Serial: NPD-MISC-2012-015

Re: Progress Energy Florida (PEF)/Levy Nuclear Plant (LNP) – SAJ-2008-00490(IP-GAH)
Groundwater Hydro-geologic Testing and Monitoring Plans

- 1) Levy Nuclear Plant Well Field Environmental Monitoring Plan (TMEM-133)
- 2) Levy Nuclear Plant Well Field Aquifer Performance Testing Plan (TMEM-135)
- 3) Comment Resolution, USACE Review of Draft LNP EMP and APT, April 2012 (with associated appendices provided on the enclosed disk)

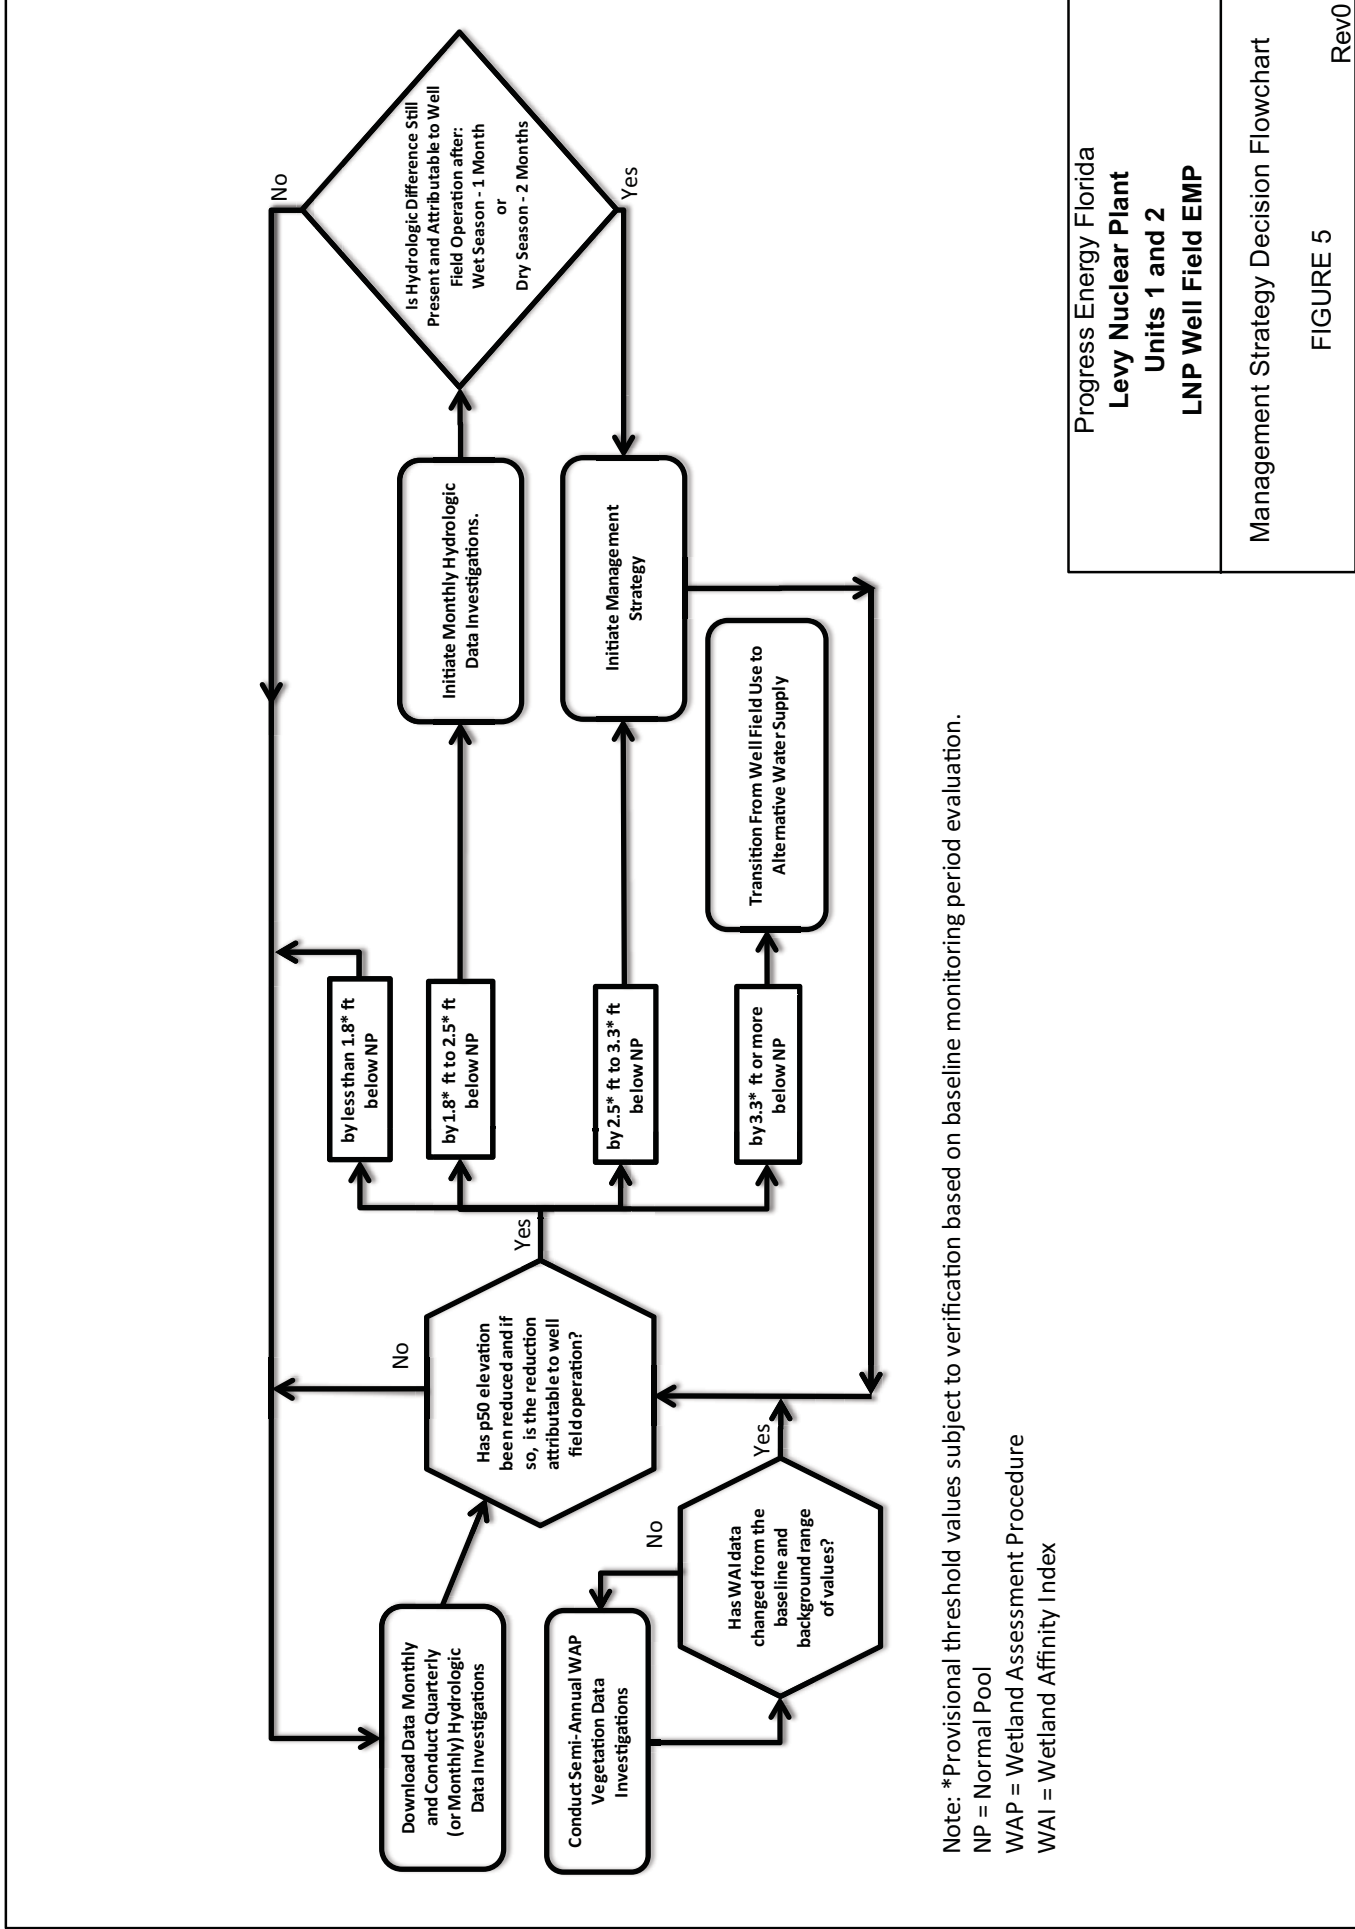
Number	Location in Draft	Comment	Resolution
19	Page 24, Diagram	Increase font size for the note about the listed thresholds being provisional. Provide documentation on how or why the thresholds (shown in the squared rectangles) were selected to be the provisional thresholds. Provide documentation supporting the provisional thresholds as ecologically significant.	Figure 5 updated. Font size increased. See resolution to Comment 8 for clarification on the development of provisional thresholds.
20	Page 25, 2nd Paragraph, number 1	Describe in further detail what is meant by "rotate pumpage between production wells."	As described in resolution to Comment 2, pumpage rotation will be used in normal operations as well as a targeted management strategy. Statement revised to read, "Reduce groundwater withdrawals or modify the well rotation schedule to reduce or eliminate the use of a particular supply well nearest the wetland area of concern."
